Some Concerns Regarding Groundwater Impact Assessments for Coal Mines in NSW

Citation: *Some Concerns Regarding Groundwater Impact Assessments for Coal Mines in NSW*, P.Turner, NSW National Parks Association, December 2016.

Figure 5. Comparison of Hcalc and Acalc with respect to Tammetta’s database

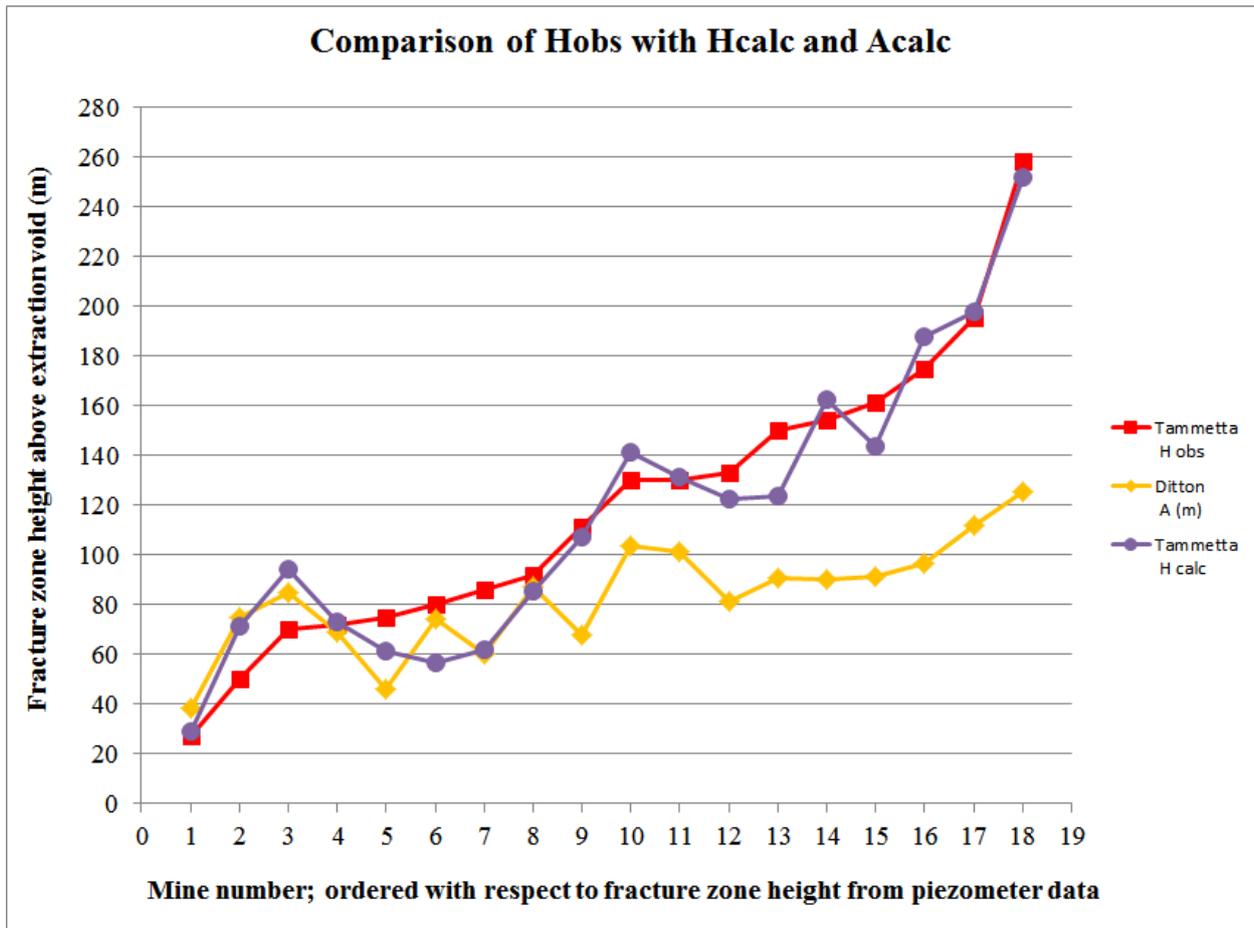
As Figure 5 indicates, Ditton's 'geometry' equation[26] increasingly underestimates the drainage zone height as the observed height, determined from centre-panel piezometer data, increases. The largest deviation is for Longwall 409 of the Springvale mine. In order to return a fracture zone height matching the 258 metre drainage zone height indicated by the piezometer data from Longwall 409 (see Section 9 and Fig. 14), the t' parameter of Ditton's geology equation would need to be 7.8, using the mining geometry given by Tammetta.[16][41] Ditton recommends a minimum t' of 40 for mining at the depth of Longwall 409. Ditton's interpretation of the Springvale data is very different to that of Tammetta; the Springvale data are discussed in Section 9.

The Figure 5 comparison of the estimates provided by the Tammetta and Ditton equations indicates that for other than cases with modest mining parameters, the application of the Ditton's empirical equations will underestimate the height of the drainage zone obtained from centre-panel piezometer data.

Figure 8. Variation of Ditton fracture zone height estimate with adjustment parameter t'

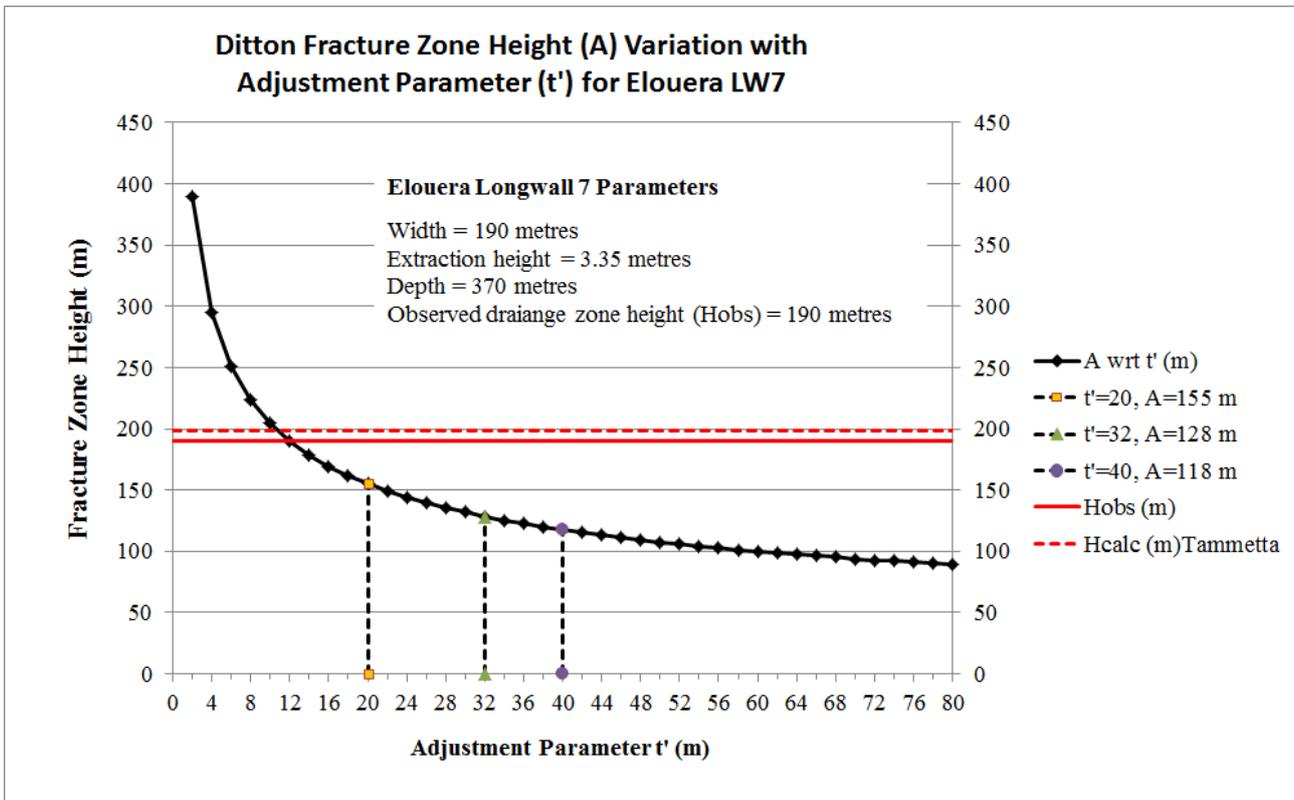
Figure 8 depicts changes in the Ditton's geology equation fracture zone (A zone) height estimate with varying adjustment parameter t' for the mining parameters of Elouera Longwall 7. Data from piezometers installed in a centreline bore, DDH9, over this extraction indicate a drainage zone height of 186 metres (discussed in Section 12). A t' value of 12.5 is needed in order for the Ditton's geology equation to return a fracture zone height that matches the drainage zone height indicated by the centreline bore data. As Figure 9 indicates, there are no unusual geological features over this longwall panel. Geology does not provide an explanation for the low t' value needed to match the piezometer data.

Figure 14. Hydrological zone of influence of Springvale Longwalls 409 and 411

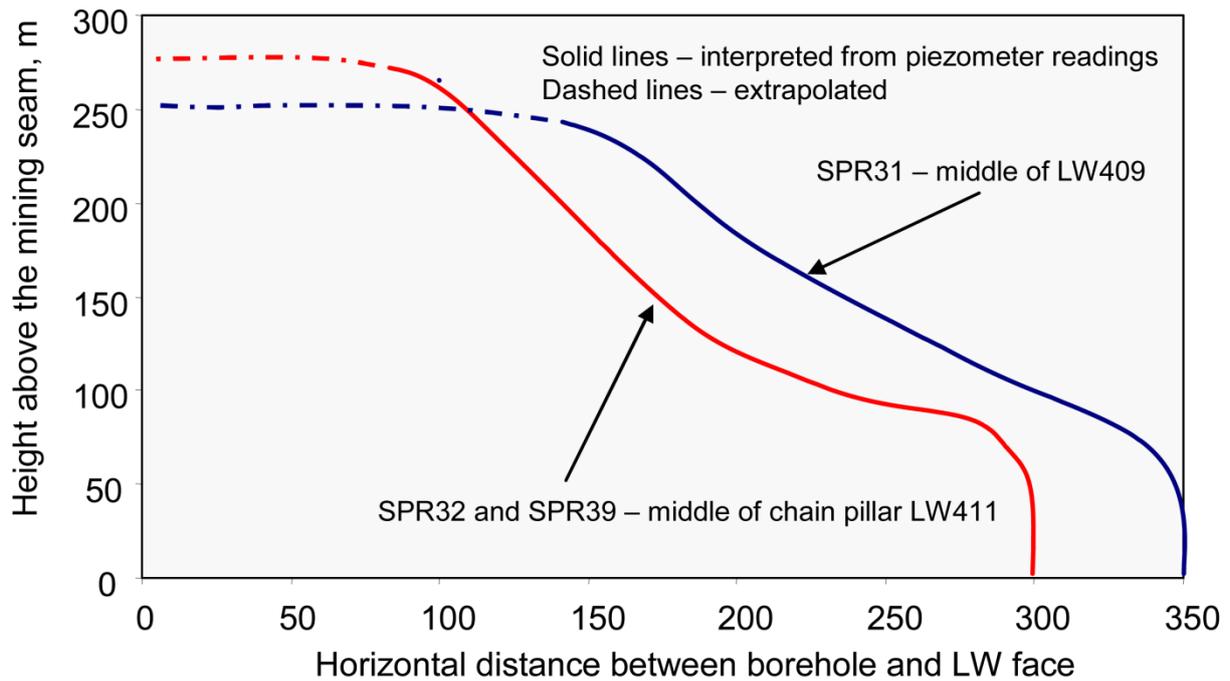
The 2007 CSIRO assessment[40] of SPR31 data during the mining of Longwall 409 found that the "zone of influence" of the extraction extended to 250 metres above the extraction (see Fig 14). The zone of influence was determined by monitoring the bore's piezometers as the longwall machine approached and plotting the distance at which a piezometer at a given height first registered a clear response (pressure head loss of 5 metres[53]) to the approaching drainage zone.

That the graphs in Figure 14 approach a plateau with decreasing distance to the longwall face indicates that the piezometer response primarily reflects horizontal propagation of depressurisation in line with the developing and approaching collapsed zone. Though much slower, vertical diffusion of pressure loss above the peak of the collapsed zone would preclude complete plateauing of the response - until depressurisation reached the surface.

Figure 21 Summary of Groundwater Depressurisation and Estimated Height of Connected Fracturing

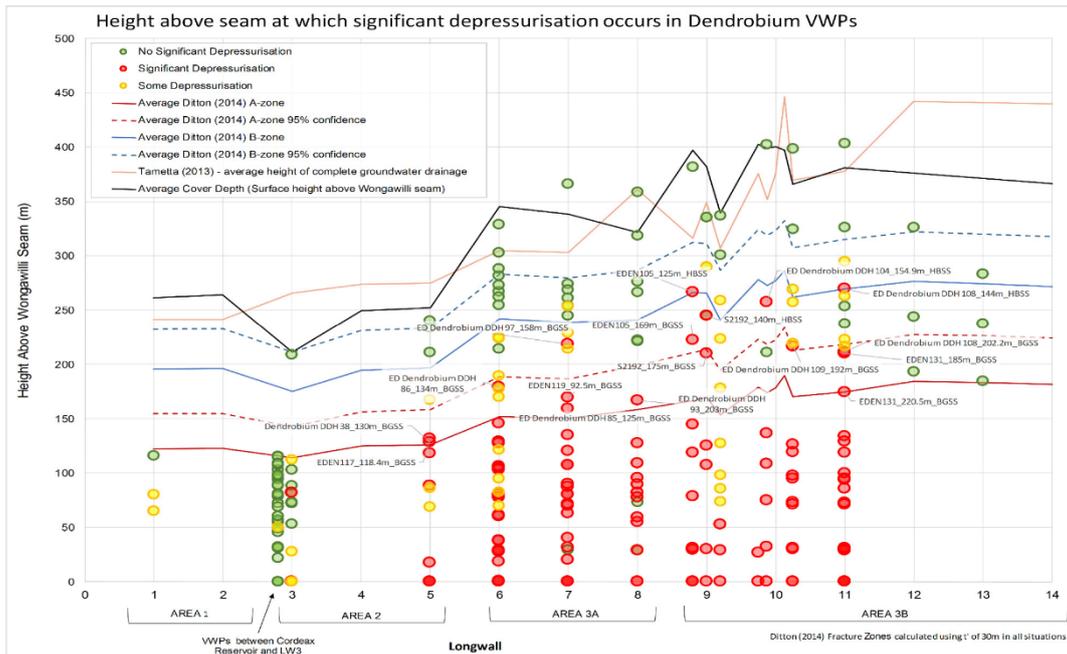
The presentation of the piezometer response assessment in Figures 21 and 22 of the HydroSimulations report (Figs. 24 and 25 below) is unhelpful and misleading. The majority of the instruments represented in Figure 21 are not identified and none are identified in Figure 22. Noting that counting is complicated by overlaps (see Fig. 24 below), of some 192 instruments represented in Figure 21 only 17 appear to be identified.

Of note, the instruments that are identified are those represented as reporting significant depressurisation. None of the instruments classified as reporting some depressurisation or no significant depressurisation are identified. It’s then impossible to gauge where they are located and, accordingly, whether or not their response classification would suggest they contradict the Tammetta equation. That is, Figure 21 in the HydroSimulations report provides no support or substantiation for the above quote.

Most of the instruments in Figure 21 of the report are placed on a vertical line that has a longwall number beneath it, while the rest are to the side of a labelled vertical line (see Fig 24 below). This might suggest that those on the vertical line are located over the centreline of the given extraction, but in general that’s not the case. For example, instruments in the TARP bores DDH85/S1870 and DDH119/S1992 are represented on a vertical line in Figure 21, but both bores are beyond the finishing ends of the associated extractions. Others are located in side-panel bores or bores over pillars.

There are only two centreline bores represented in the Figure 21 (Fig.24 below) and they are bores S2192 and DDH104, and their instruments fail well before the host bore is undermined (see Sections 15.1.14 and 15.1.15 below).

Noted in the sections below are examples of piezometers that record significant declines in pressure head, but do not appear to be represented in Figure 21. For example, the figure includes and identifies two instruments from Longwall 9 centreline bore S2192, with the uppermost shown being that at 140 metres below the surface. Reference to Figure 38 below finds that the instrument at 95 metres below the surface undergoes a similar decline to that of the lower instrument, yet it doesn't appear to be shown in Figure 21. Data from this bore are further discussed in Section 16. There would appear to be other instruments that have not been included in Figure 21 that would be regarded as showing a significant response.

Limiting the insight that might have been provided by Figures 21 and 22, HydroSimulations don't specify how the three categories represented in Figure 21 were defined and applied. The CSIRO Springvale study[40] (see Section 9 below) used a pressure loss of five metres in identifying the point at which a piezometer first responded to the approach of Longwalls 409 and 411. Depending on the distance between the drainage zone boundary and the piezometer, a loss of five metres or more recorded by an off-panel piezometer in a saturated zone may well be significant.

Figure 22 Summary of post-mining Groundwater Pressures near Areas 3A and 3B

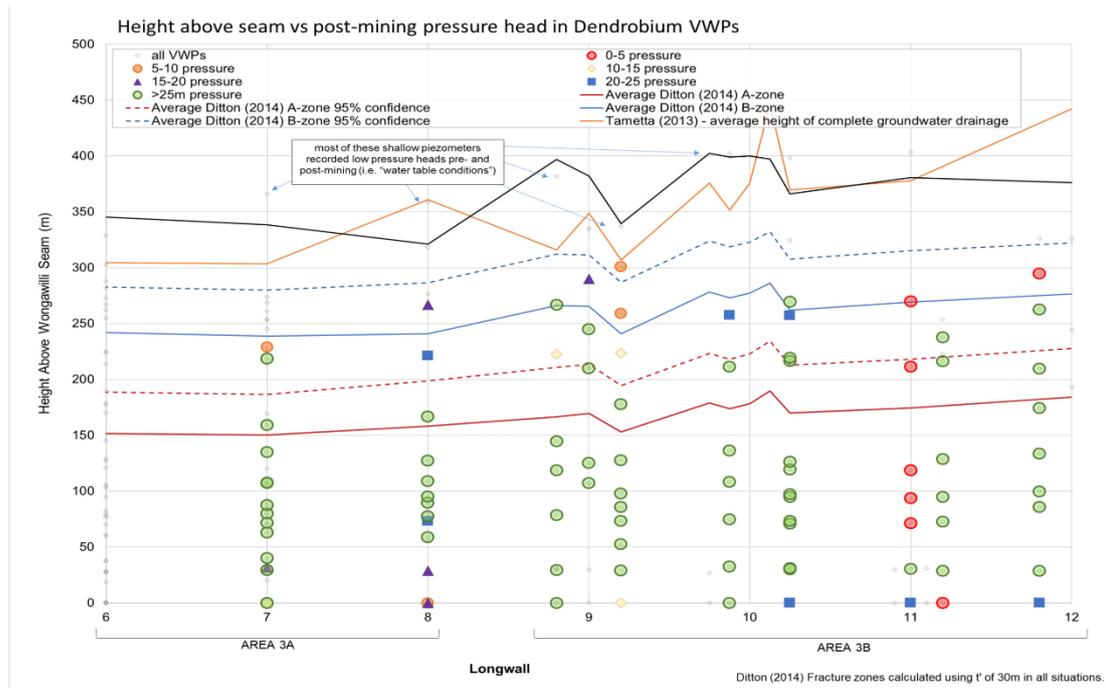
The HydroSimulations assessment finds few zero or near-zero pressure head measurements in the set of (unidentified) piezometers represented in Figure 22 of the report (Fig. 25 below). The consultants again suggest that this observation does not support the concept of a zone of complete depressurisation extending upward from the goaf up to the height estimated by the Tammetta equation; *"The data does do not support the concept of a zone of zero pressure extending upward from the goaf up to the Tammetta H height."* The spatial relationship of the bores to the relevant extraction isn't given and without identification can't be determined.

Without further information Figures 21 and 22 of the HydroSimulations report (Figs. 24 and 25 below) provide no insight into the height of the drainage zones over the Dendrobium mine and, on the contrary, appear to be misleading.

Figure 26. Pressure heads recorded by Piezometers 2 and 3 in bore DDH39 over Longwall 3 in Area 2 of the Dendrobium mine.

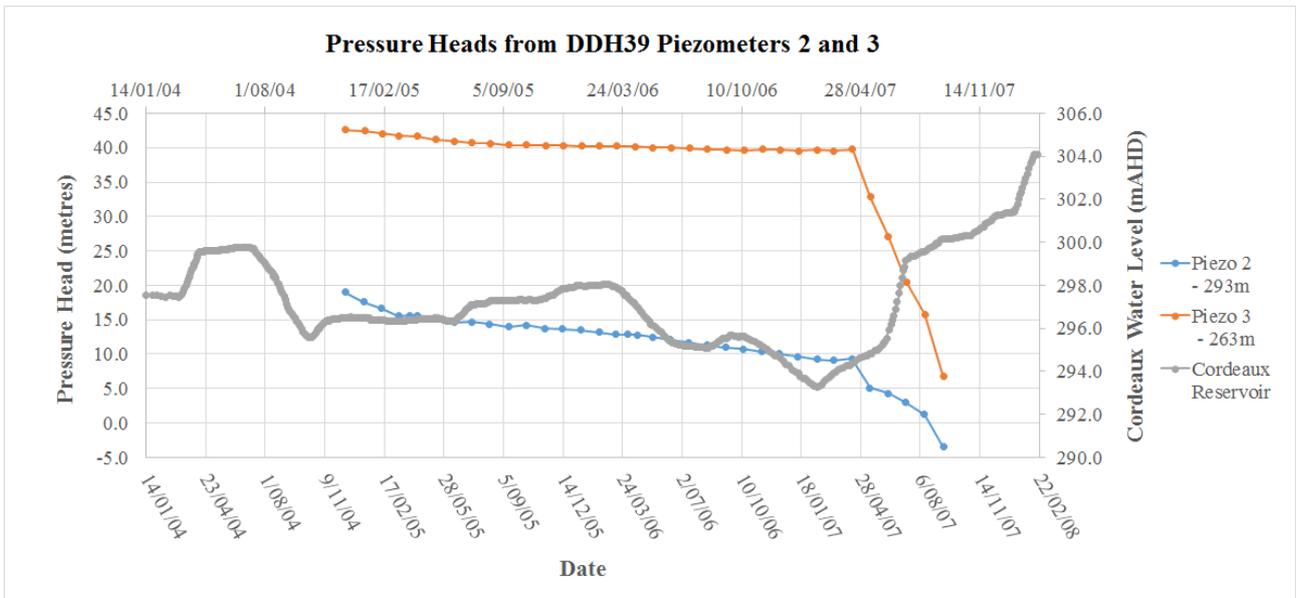
As reflected in Figure 26, the pressure head reported by Piezometer 3 at 152 metres below the surface in the Scarborough Sandstone falls from approximately 40 to 7 metres between April and September 2007; a pressure head loss of 33 metres in just 6 months. The September pressure reading is the last reported, presumably reflecting failure at some point between mid-September and mid-October. By mid-September 2007 the approaching longwall face was approximately 170 metres south of DDH39.

Piezometer 2 in the Stanwell Park Claystone at 122 metres below the surface also failed between September and October 2007. Providing a lower bound of approximately 114 metres for the height of the Longwall 3 drainage zone, this piezometer reports a pressure head loss of approximately 20 metres and appears to have become dry shortly before failing. This instrument is not represented in either Figure 21 or Figure 22 of the 2016 HydroSimulations report (Figs. 24 and 25 below). The Tammetta equation estimates a drainage zone height of 216 metres for the 3.2 metre cutting height used for most of Longwall 3. The Ditton geology equation estimates an A zone height of 110 metres, just below the lower bound suggested by DDH39 Piezometer 2. The Ditton A95 height estimate is 135 metres; A95 is an estimated upper height limit for which there is a 95% probability the actual height will be somewhere below this limit.

Figure 27. HydroSimulations piezometer location map from the March 2014 Dendrobium groundwater assessment.[23]

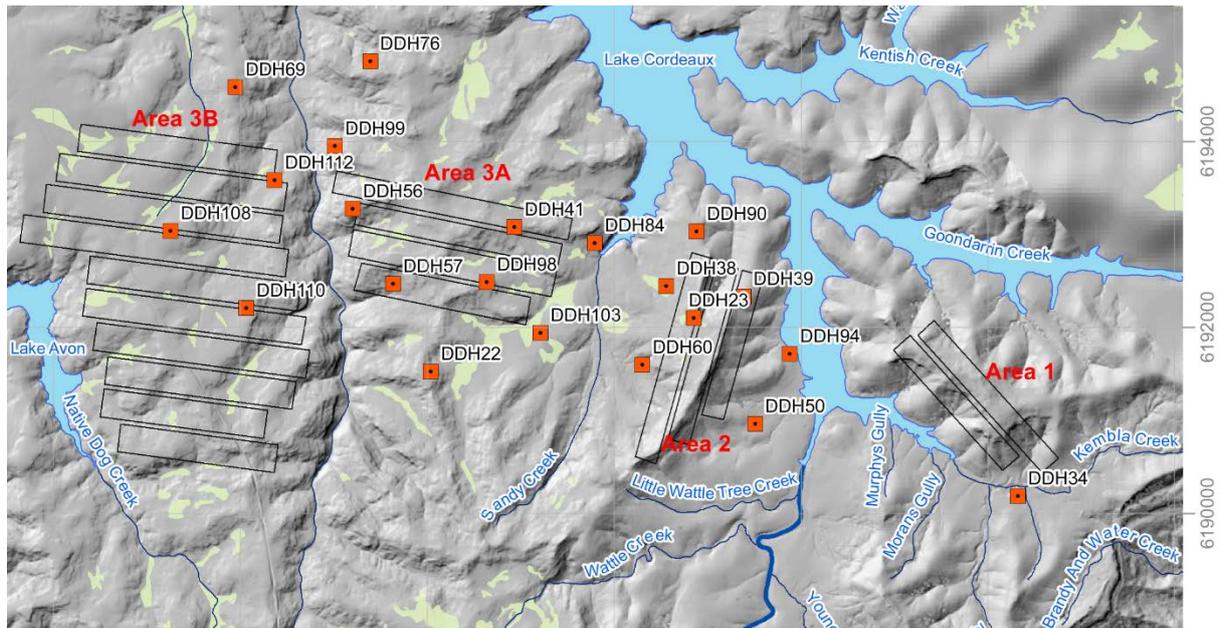
As discussed in Sections 15.1.4 and 15.1.8, the March 2014 assessment map does not show DDH117. This important site is shown in Dendrobium end of panel reports (see Fig. 31 and in the Coffey maps given in the 2012 Coffey assessments (see Fig. 28).
